KEENE PLANNING BOARD  
Council Chambers, Keene City Hall  
May 26, 2026  
6:30 PM

1. **PB-26-10 - Habitat for Humanity Duplex, Cottage Court Conditional Use Permit** — Applicant SVE Associates, on behalf of owner Monadnock Habitat for Humanity, proposes to construct a 1,364 sq-ft duplex at the property located at 0 Grove St. (TMP# 585-057-000). The parcel is ~.11 ac and is located in the Residential Preservation District.

**To:** Planning Board

Figure 2. A snippet of the proposed conditions plan showing the proposed layout of the duplex at Grove St.

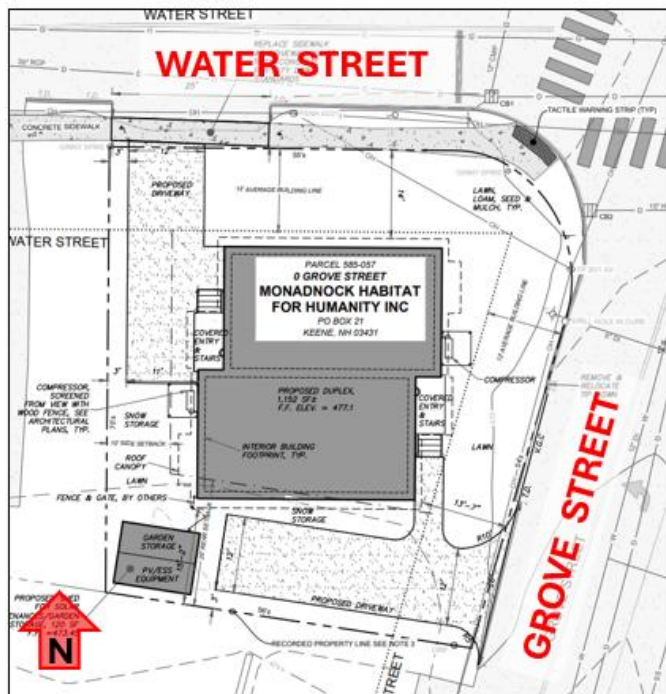
**17.4 Permitted Uses:** The proposed duplex is allowed in the Residential Preservation District with a Cottage Court Conditional Use Permit. An accessory shed is proposed in the southwest corner of the site to house mechanical equipment and provide storage areas for tenants (Figure 2). This standard appears to be met.

Figure 2. A snippet of the proposed conditions plan showing the location of the delineated wetlands and 30-ft surface water buffer on the parcel at 30-42 Production Ave.

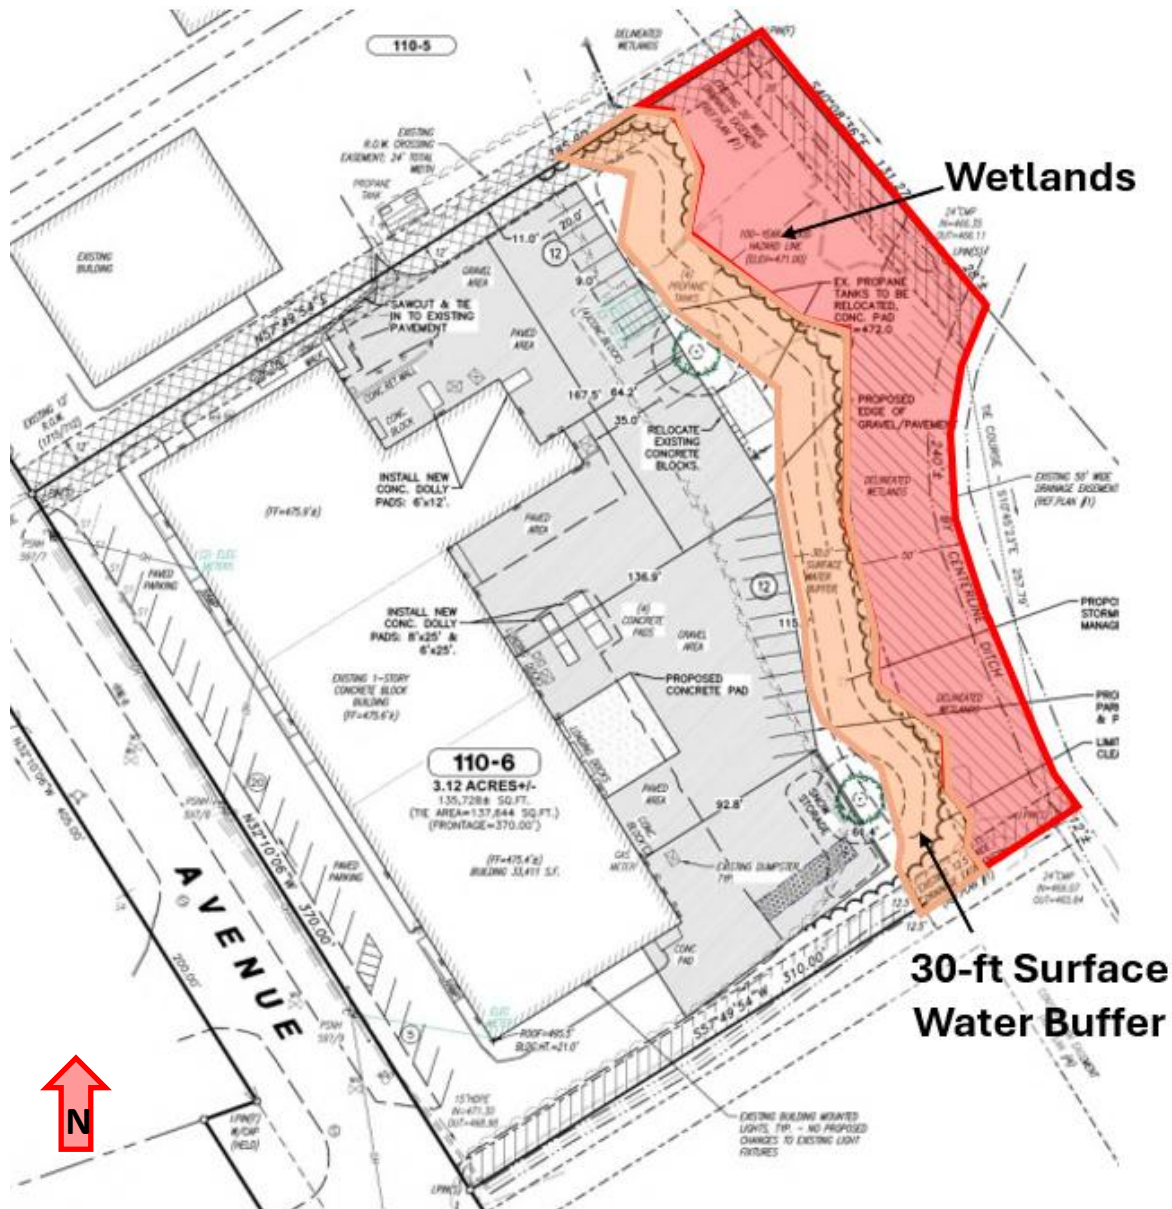
**2.A Relocation of Proposed Use / Activity:** The applicant proposes to formalize and expand the rear parking area by adding 24 additional parking spaces. The expanded parking area will provide more space for tenants to accept deliveries by large trucks and solve existing drainage issues. The parking lot is designed to pitch to the rear of the lot into a detention basin at the back of the building. The site is bounded on its eastern side by an area of wetlands, which run parallel to the City’s tax ditch. Figure 2 shows the location of the wetlands in red and the 30-ft surface water buffer in orange.

Figure 2. A snippet of the proposed conditions plan showing the proposed layout of the development.

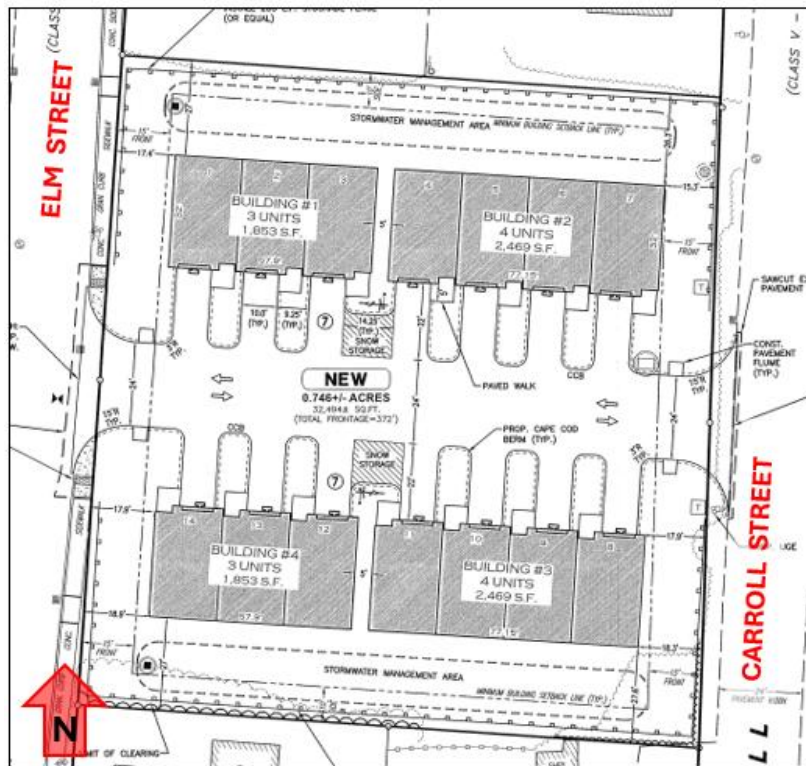
B. **Parking:** Cottage Court developments must provide at least one parking space per unit and no more than one parking space per bedroom. Each of the 14 units will have two bedrooms, therefore a minimum of 14 parking spaces and a maximum of 28 spaces are required. The plan shows 28 parking spaces – 1 in the garage for each unit and 1 in a surface-level parking space outside the garage (Figure 2). This standard appears to be met.
